**SUBJECT:** COMANCHE PEAK NUCLEAR POWER PLANT, UNITS 3 AND 4  
DOCKET NUMBERS 52-034 AND 52-035  
RESPONSE TO REQUEST FOR ADDITIONAL INFORMATION NO. 4678

**RAI NO.: 4678 (CP RAI #172)**

**SRP SECTION: 06.04 – Control Room Habitability System**

**Figure 06.04-9-1. Chlorine Release - CHEM Results (Concentration inside Control Room)**

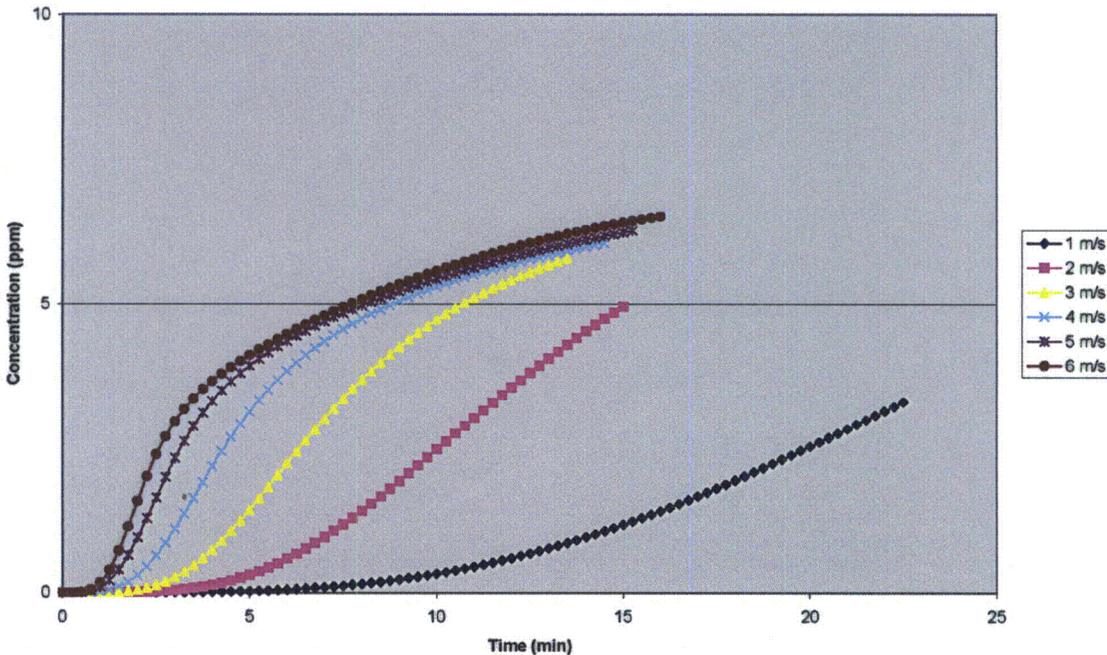
- 3. Demonstration of conservatism for the selection of Pasquill stability class and wind speed in the HABIT analysis**

FSAR Sec. 6.4.4.2 states that the meteorological condition assumed for the analysis is conservatively set at G stability and 2.5 m/s wind speed. Provide HABIT run results to demonstrate that the selected data set is conservative.

- 4. Demonstration of peak chemical concentration in main control room obtained from HABIT run for all chemical release hazards under analysis.**

FSAR Sec. 6.4.6 concludes that no instrumentation to detect and alarm is required. This conclusion is based on the HABIT run that no hazardous chemical concentrations will exceed the IDLH. To demonstrate that the IDLH has not been exceeded, it is important to verify that the HABIT calculation has not terminated before the peak concentration has occurred. Please verify that the HABIT calculations show the concentration has peaked and is decreasing (or has leveled-off) before the calculation has terminated. Provide the numeric output of the portion of HABIT run that demonstrates the peak chemical concentration in main control room has been calculated.

3. The HABIT sensitivity analysis compared results at Classes E, F and G stability and demonstrated that the use of Class G stability is the most conservative. However, as Class G stability occurs less than 5% of the time at the CPNPP site (see Table 06.04-9-1 below), Class F stability is utilized in the HABIT sensitivity analysis per Appendix A of RG 1.78. HABIT sensitivity analyses for Class F stability and a range of wind speeds from 1 m/s to 6 m/s was performed to determine the worst wind speed. A summary of these results are located in Figure 06.04-9-1, which are the results from CHEM (a determination of the chemical concentration inside the control room) and Figure 06.04-9-2, which are the results from EXTRAN (a calculation of the chemical concentration outside the control room at the air intake). The worst-case wind speed was 6 m/s as shown in Figures 06.04-9-1 and 06.04-9-2, below.

4. The new HABIT CHEM analysis results demonstrate that the calculation is asymptotically approaching a maximum for the worst case 6 m/s wind speed (see Figure 06.04-9-1). For lower wind speeds with lower calculated control room concentration curves that have not peaked, the

results are analyzed in terms of the 0.08 ppm odor threshold (from NUREG/CR-6624) for chlorine. In each case, the time between the 0.08 ppm odor threshold limit and the calculated highest concentration is well in excess of the RG 1.78 value of 2 minutes to don SCBAs. As the IDLH value for chlorine is 10 ppm, there is no threat to CRH.
